PROJECT REFERENCE NO.	SHEET NO.
R-3100B	EC-19/CONST.05
RW SHEET NO.	
ROADWAY DESIGN ENGINEER	HYDRAULICS ENGINEER

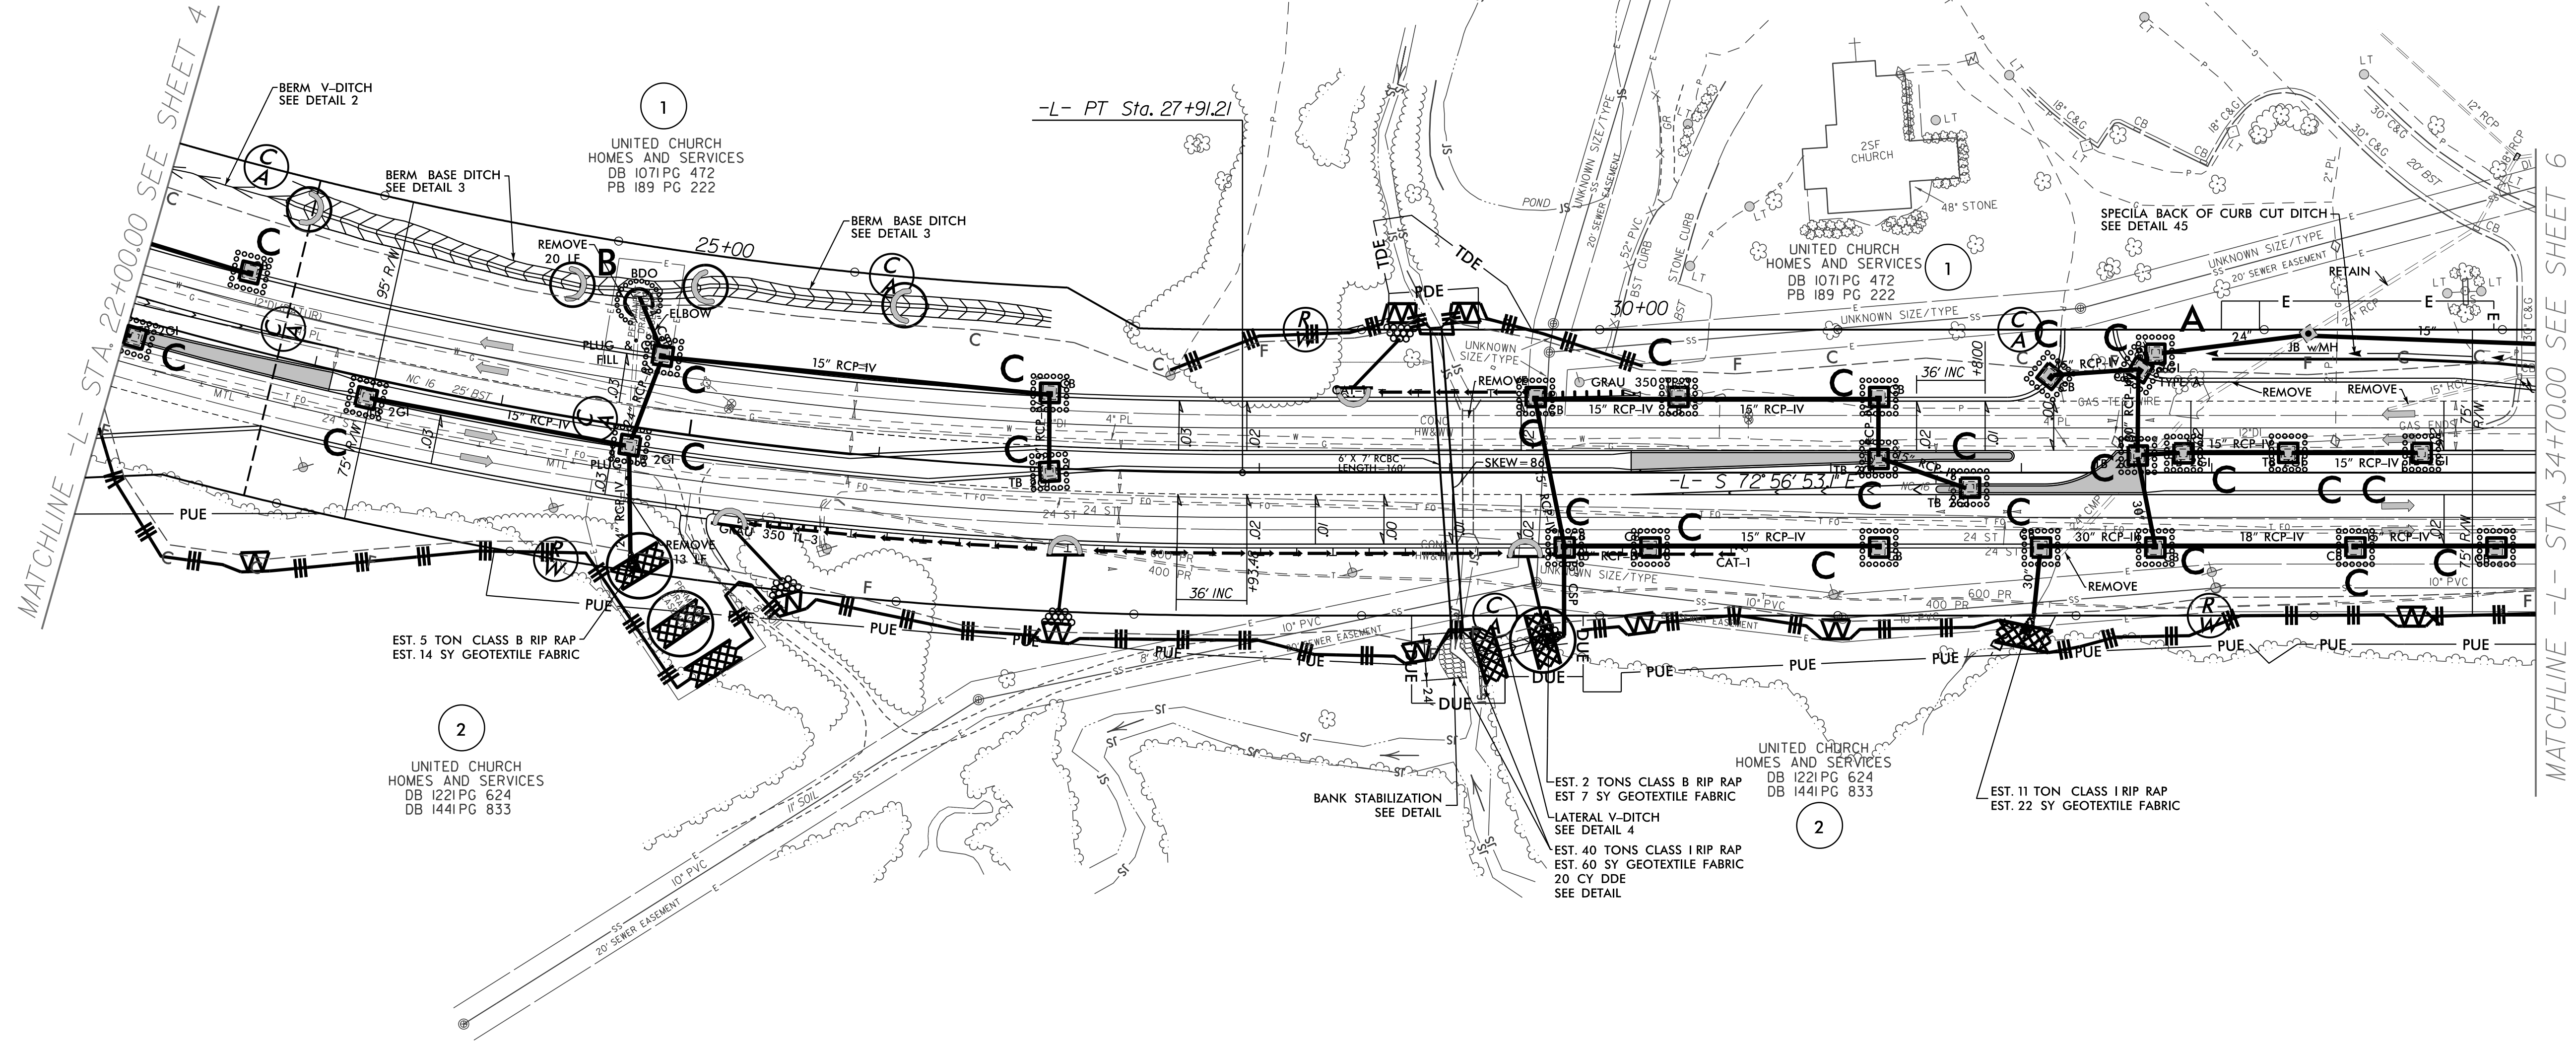
DATE: 06/09/2016 ADDED TCE ONTO PACEL FOR SLOPE CONSTRUCTION STA 33+25 TO STA 34+48
